**THE CORPORATION OF THE TOWNSHIP OF WELLINGTON NORTH
PUBLIC MEETING AGENDA TUESDAY JANUARY 13, 2026 @ 7:00 P.M.
ARTHUR & AREA COMMUNITY CENTER, UPPER HALL**

ZBA 05/25 & OPA-2025-03 Tribute/Sorbara Arthur Holdings Inc.

DATE: January 2, 2026
TO: Darren Jones, C.B.O
Township of Wellington North
FROM: Curtis Marshall, Manager of Development Planning
County of Wellington
SUBJECT: **Public Meeting Report**
Tribute/Sorbara Arthur Holdings Inc.
Official Plan Amendment (OPA 2025-03), Zoning By-law Amendment (ZBA 05/25) & Draft Plan of Subdivision (23T-25002)
Arthur

Proposed WHPA -A

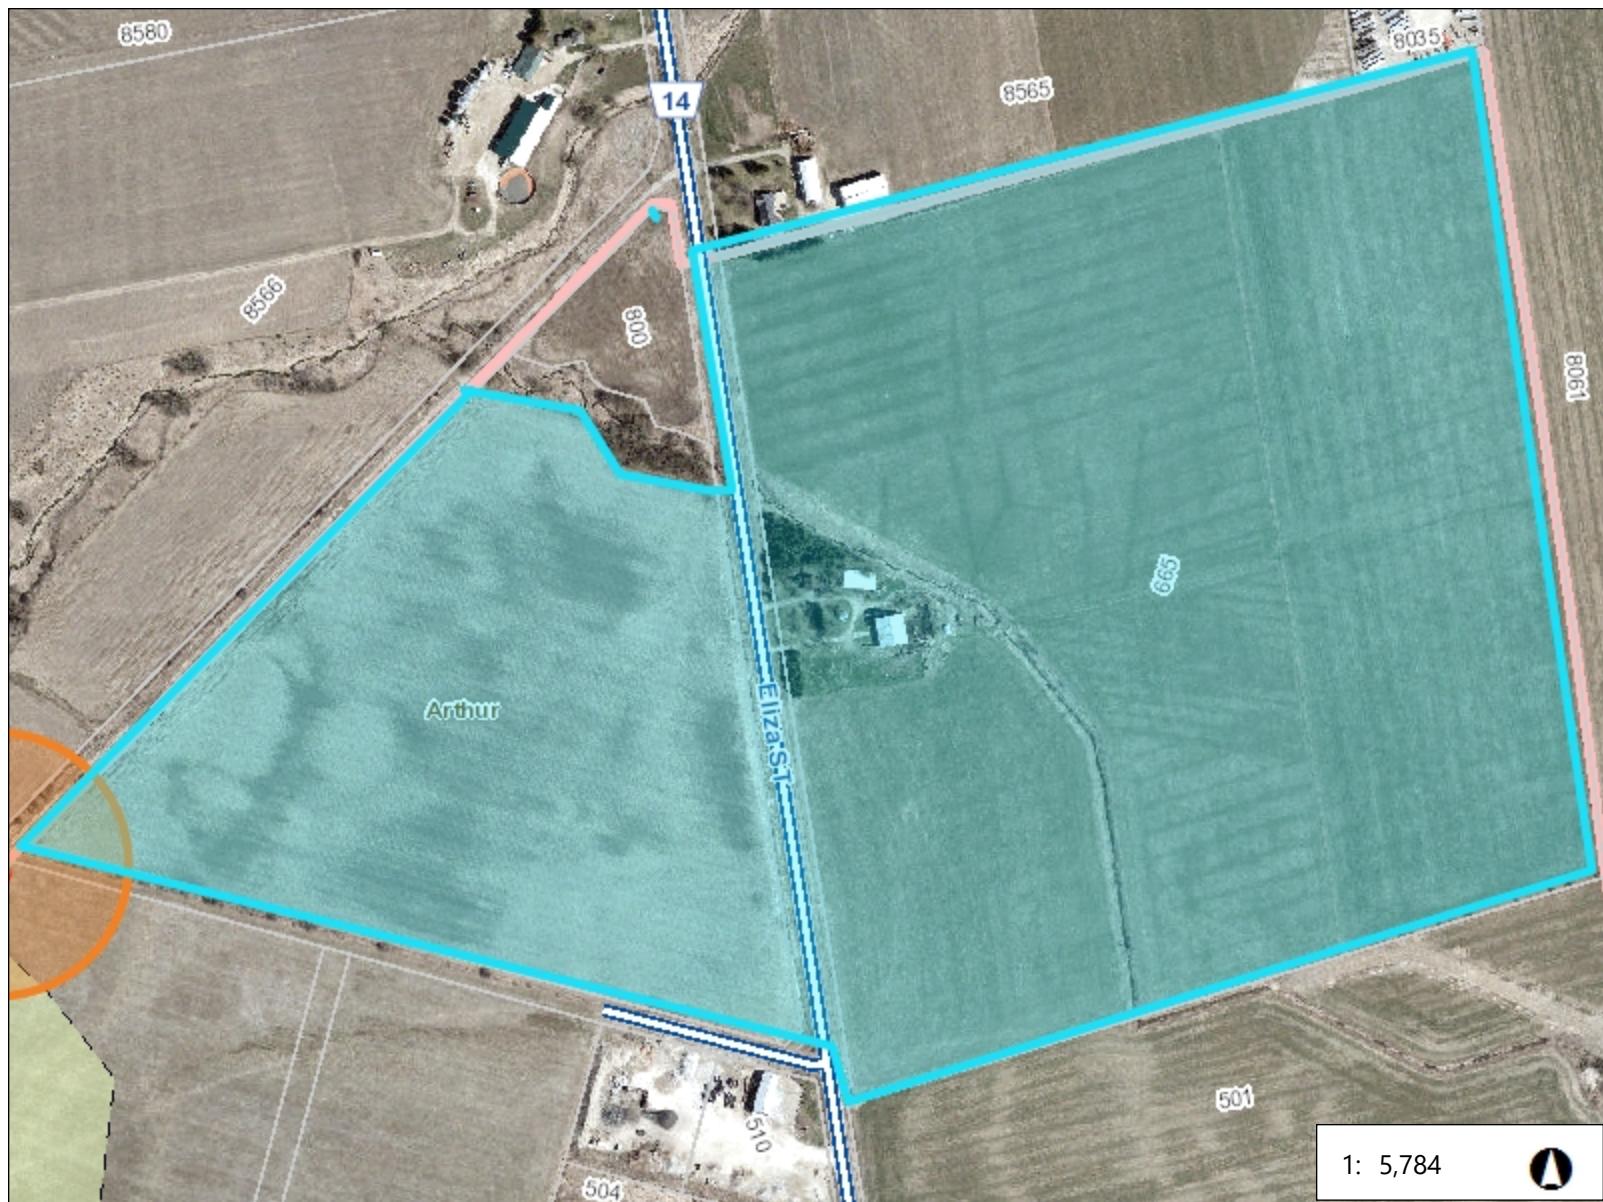
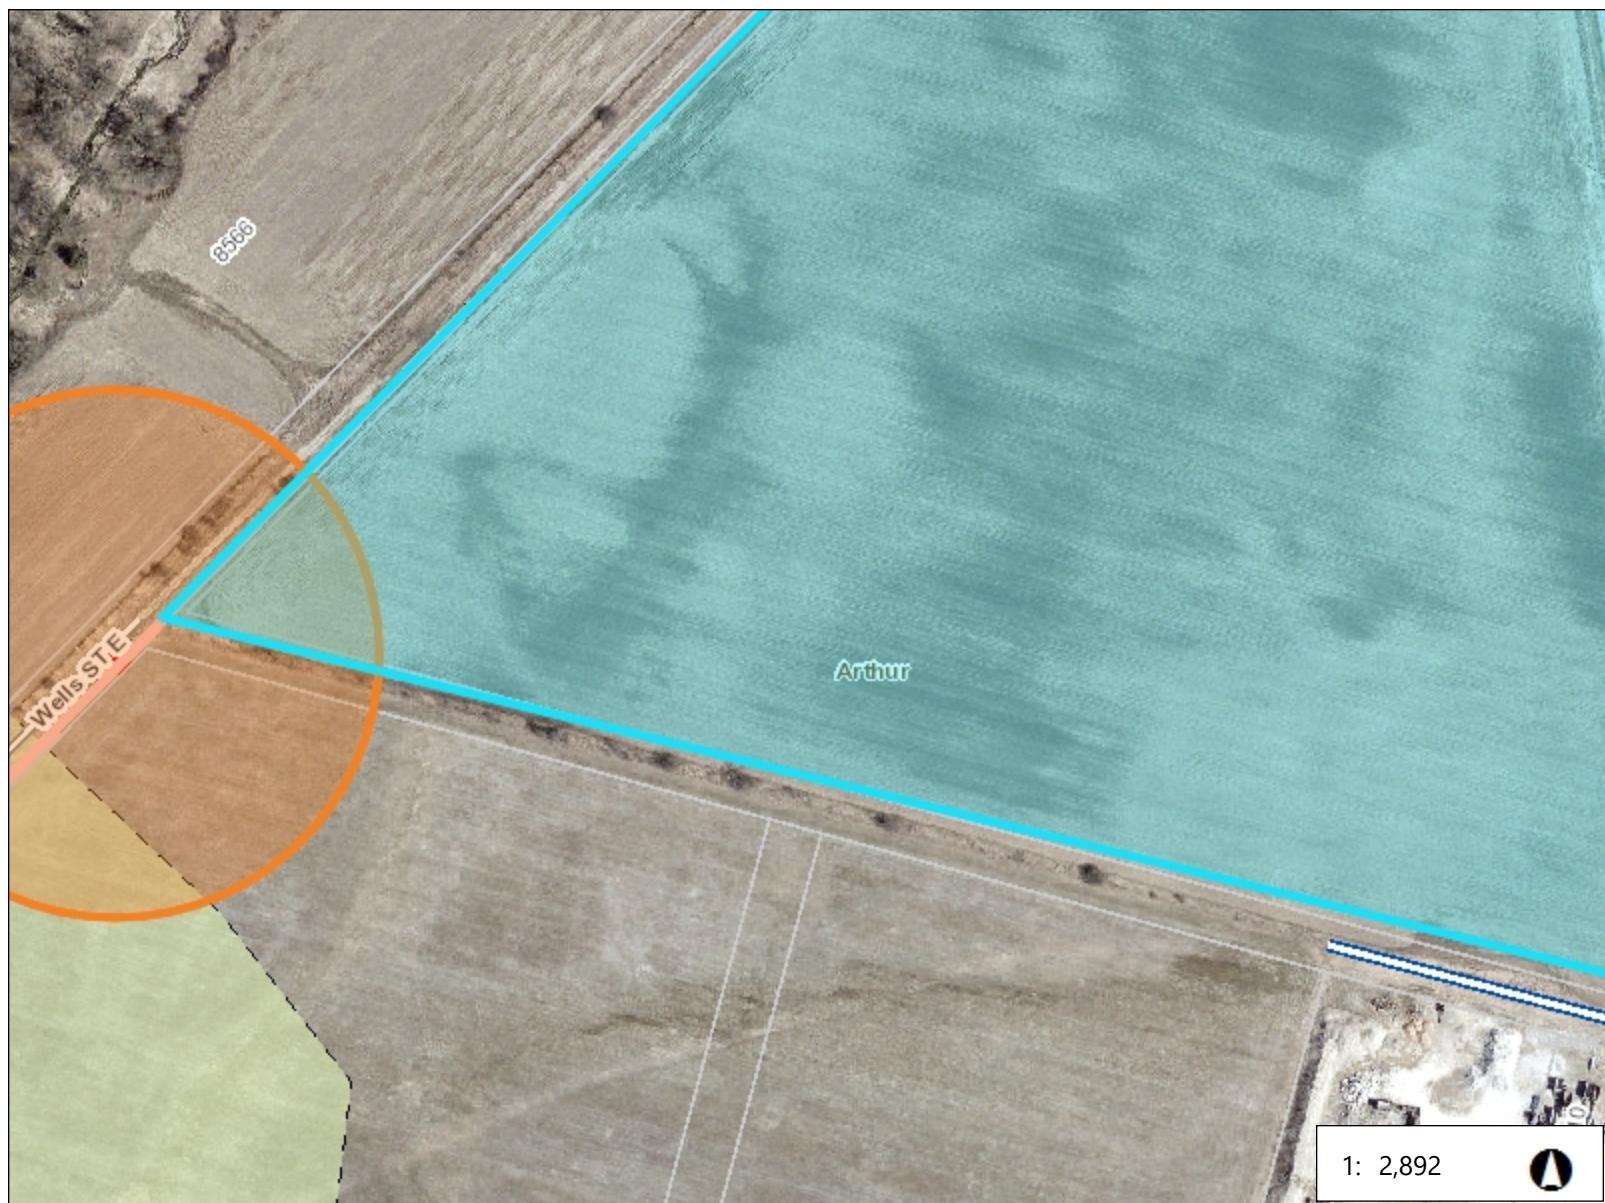
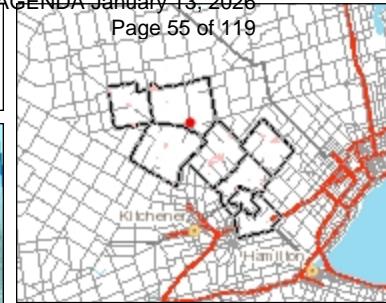
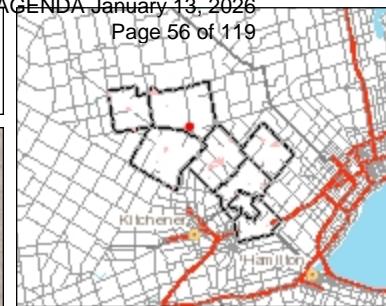
Wellington Source Water Protection (WSWP) staff have had the opportunity to review the submitted documents in support of the above noted applications. Based on our review of the submitted documents, it has been noted that future Source Protection Plan policies under the Grand River Source Protection Plan **will** apply, given the Township's proposed wells proximity to the site. See attached map.

The subject property is located within a future water quality Wellhead Protection Area for the Township of Wellington North's proposed future well. Permitting the proposed wells location does not change, this site will fall within a Wellhead Protection Area A and B, and potentially C, and/or D (WHPA-A, WHPA-B, WHPA-C, WHPA-D), representing a 100m radius and the 2, 5, and 25 year times-of-travel, respectively, with vulnerability scores ranging from 2 (low) up to 10 (high). It is recommended that the applicant reference and discuss these vulnerable areas in their reports as part of any future submissions for planning approvals. The attached maps show the applicable water quality vulnerable areas, as defined by the *Clean Water Act, 2006*, in relation to the subject property.

Permitting that the future municipal well is constructed and WHPA's delineated, this site will be located within vulnerable area(s), and such, WSWP recommends that the owners or their agents submit the following plans, reports or documentation to the satisfaction of the Township Risk Management Official:
